COLAC OTWAY SHIRE COUNCIL PLANNING COMMITTEE MEETING

PA2403395-2-4 and 6 Miller Street, Colac - Submission and Planning Application to Minister of Planning

ADDRESS AND PROPERTY DETAILS	2-4 & 6 Miller Street, Colac (Crown Allotments 1, 2 & 3 Section 48)	APPLICATION NUMBER	PA2403395
PROPOSAL	Use and Development of the Land for Group Accommodation		
PERMIT TRIGGERS	Clause 32.08-2 – General Residential Zone (GRZ1) - Use of the land for accommodation (group accommodation). Clause 32.08-10 – General Residential Zone (GRZ1) - Construction of a building or construction or carrying out works for a use in Section 2 (permit required) of Clause 32.08- 2.		
TRIGGER FOR DETERMINATION BY COMMITTEE	Submission on Planning Application to Minister of Transport and Planning		
ZONE	General Residential Zone (GRZ1)	OVERLAYS	Nil
COVENANTS	Crown Grant only, relating to mining rights. The proposal would not result in a breach of the covenant.		
CULTURAL HERITAGE	N/A		
OFFICER	Bernadette McGovan	GENERAL MANAGER	Ian Seuren
DIVISION	Community and Economy		
ATTACHMENTS	1. Plans [7.1.1 - 14 pages]

DRAWING TITLE
**SHADOW PLANS - 22
 SEPTEMBER**

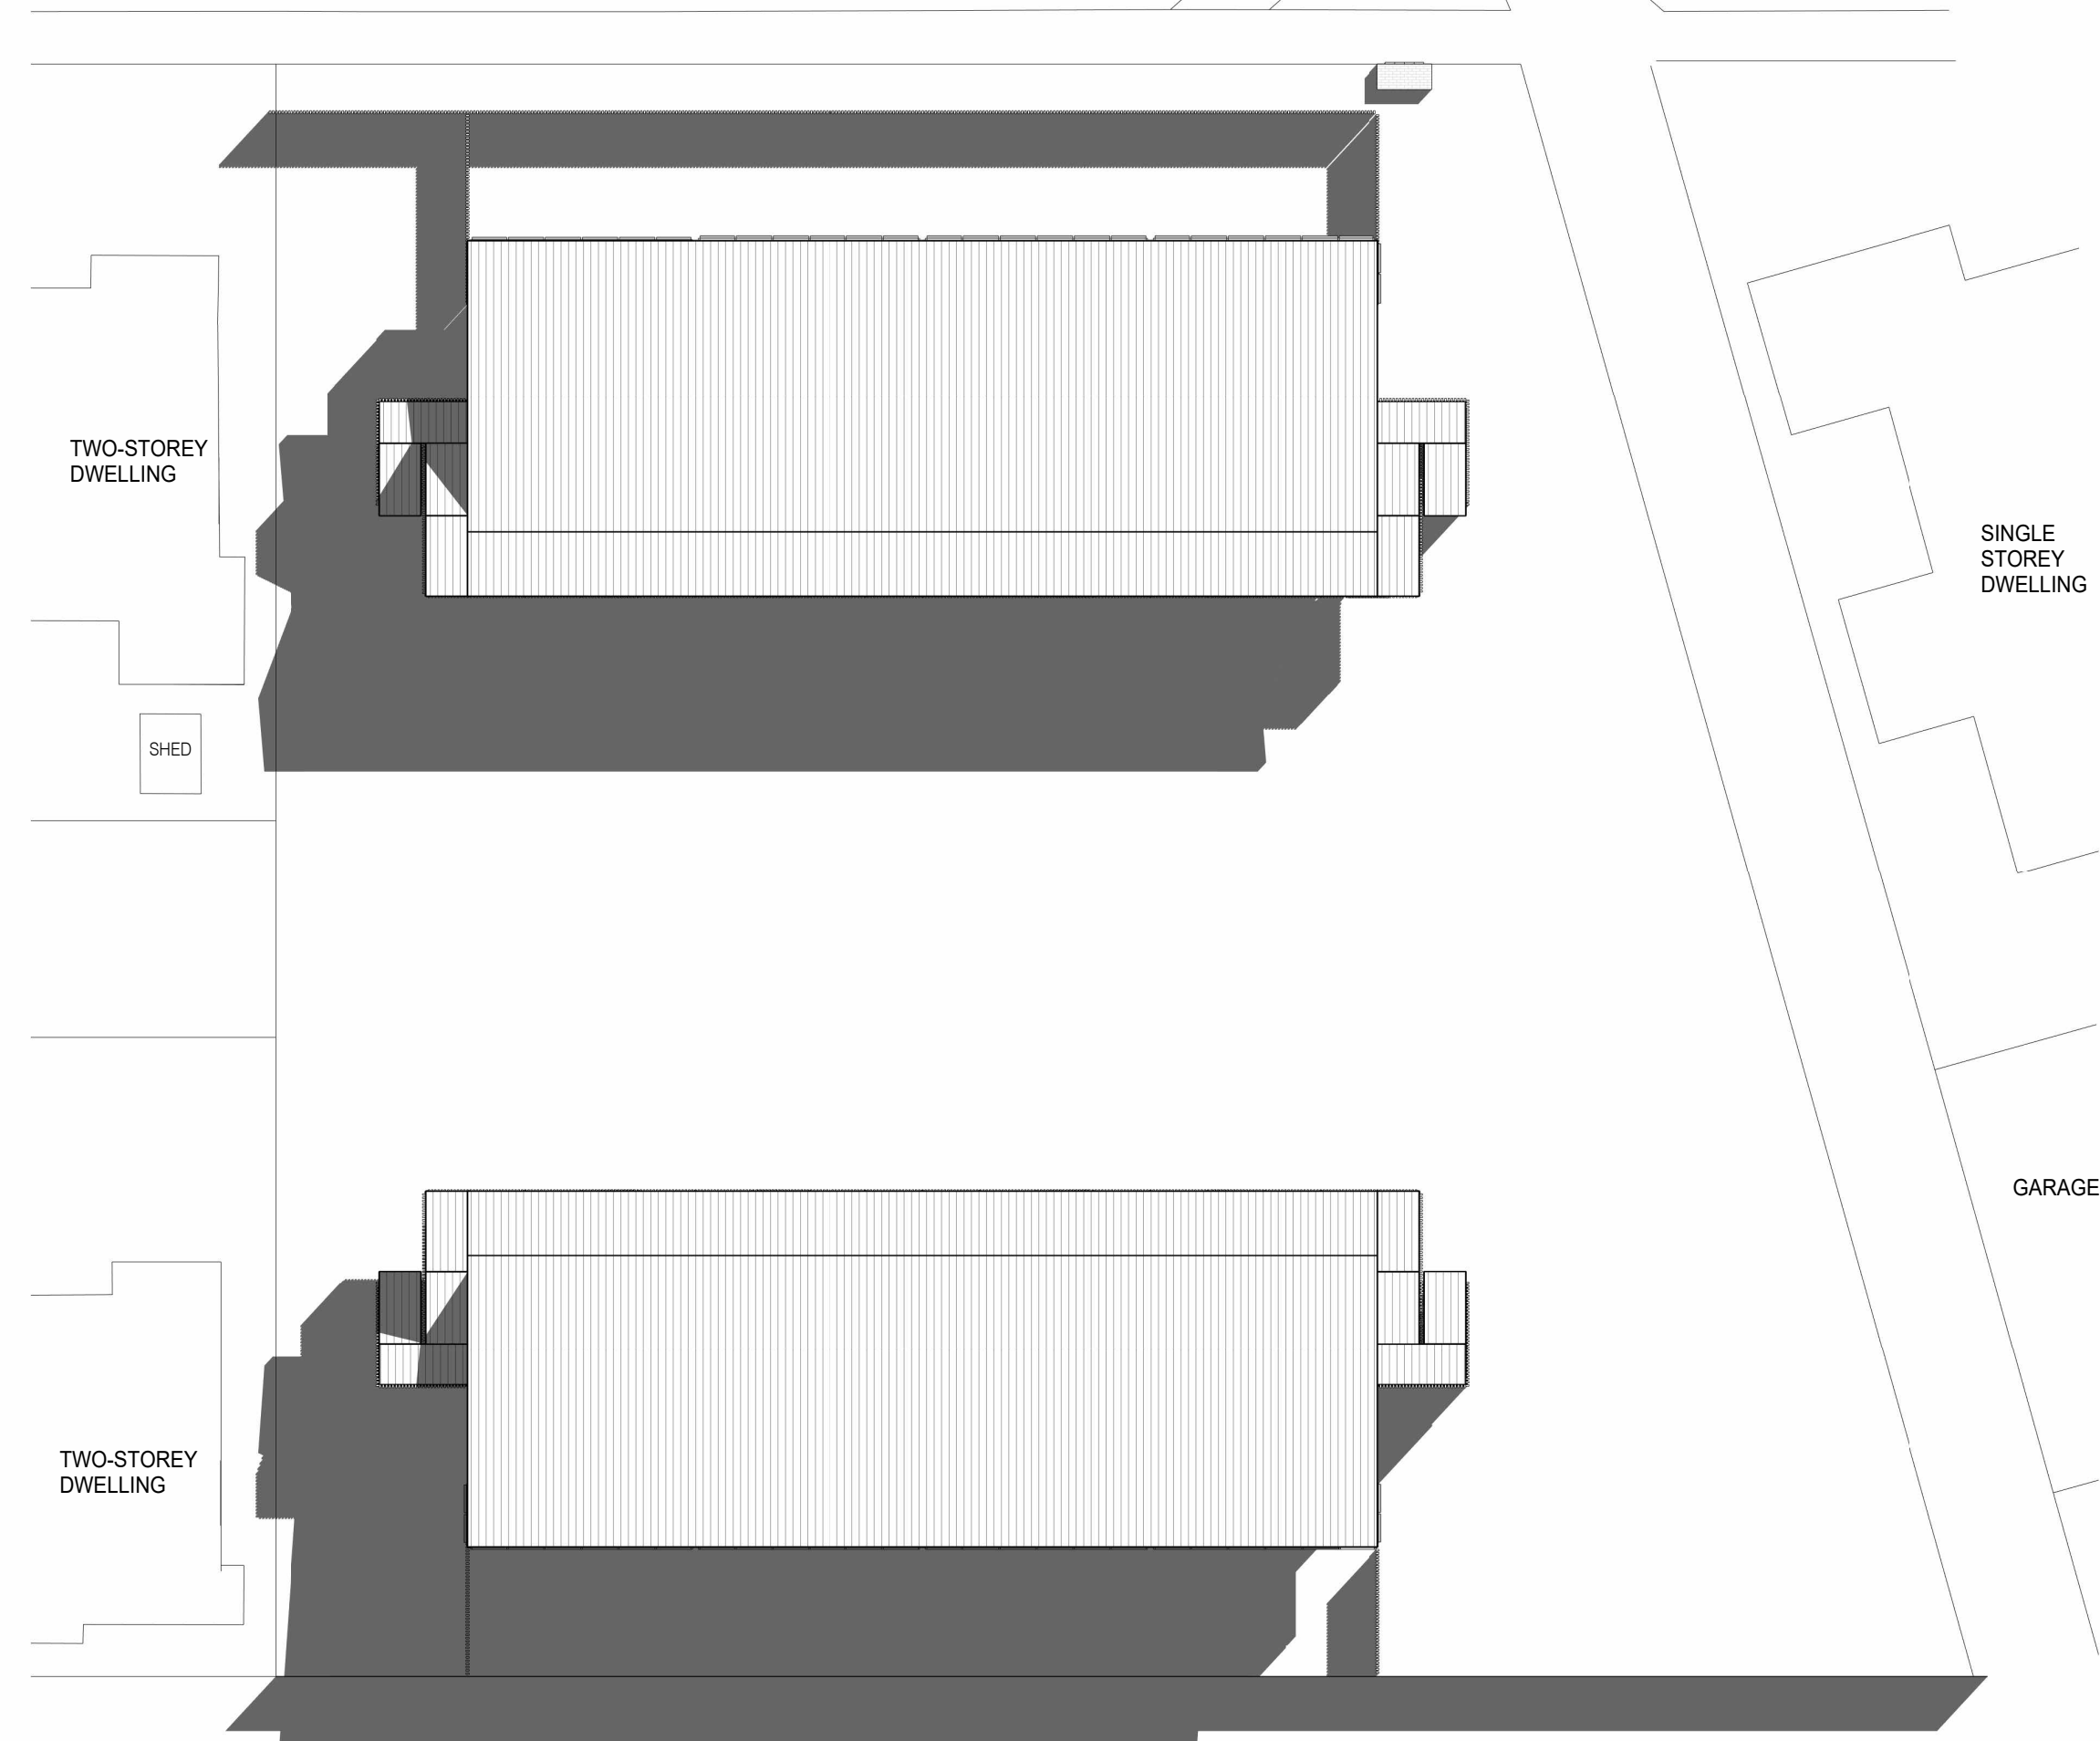
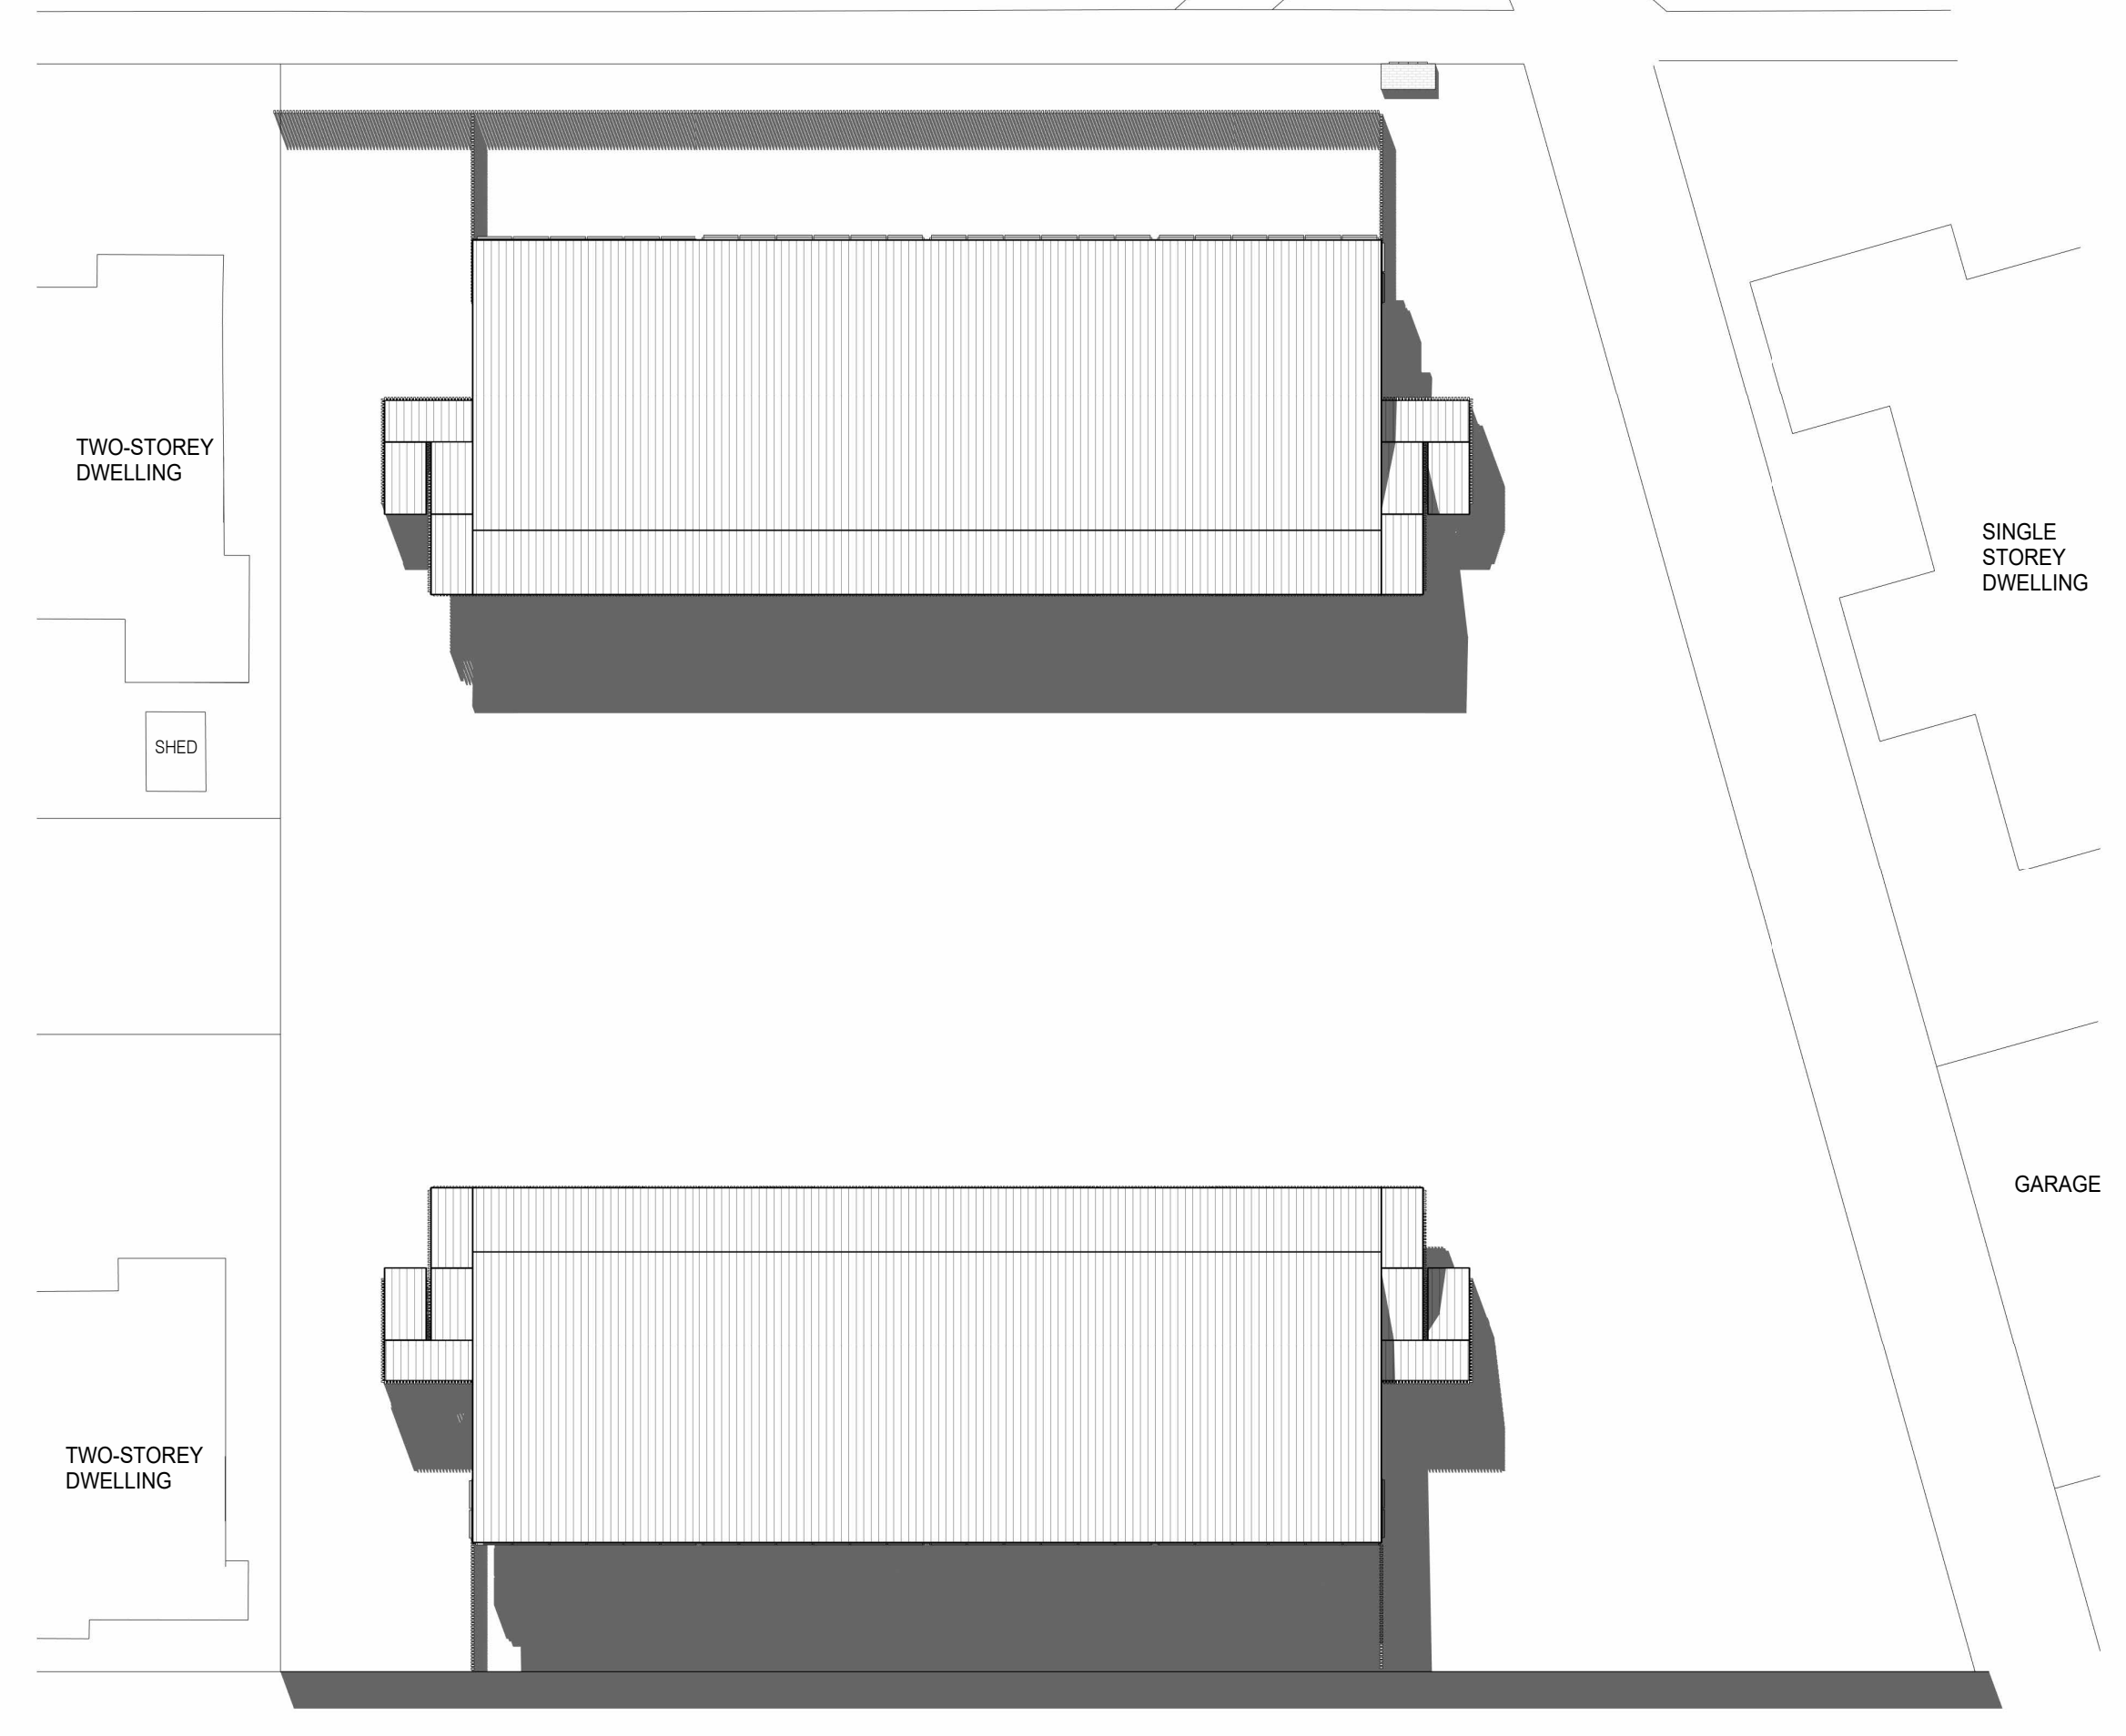
Shadow diagrams demonstrate that there would be no shading of adjoining existing private open space areas, particularly given separation provided by laneways. It is noted that the ground level courtyards to the south building would be largely shaded until 3pm on 22 September (a measure required to be assessed under the planning scheme); however, the applicant does not intend to revise the design to address this on the basis that *“reasonable amenity is provided for temporary residents of the southern units. We note the development includes communal open space which has excellent solar access and will be accessible to all residents”*.
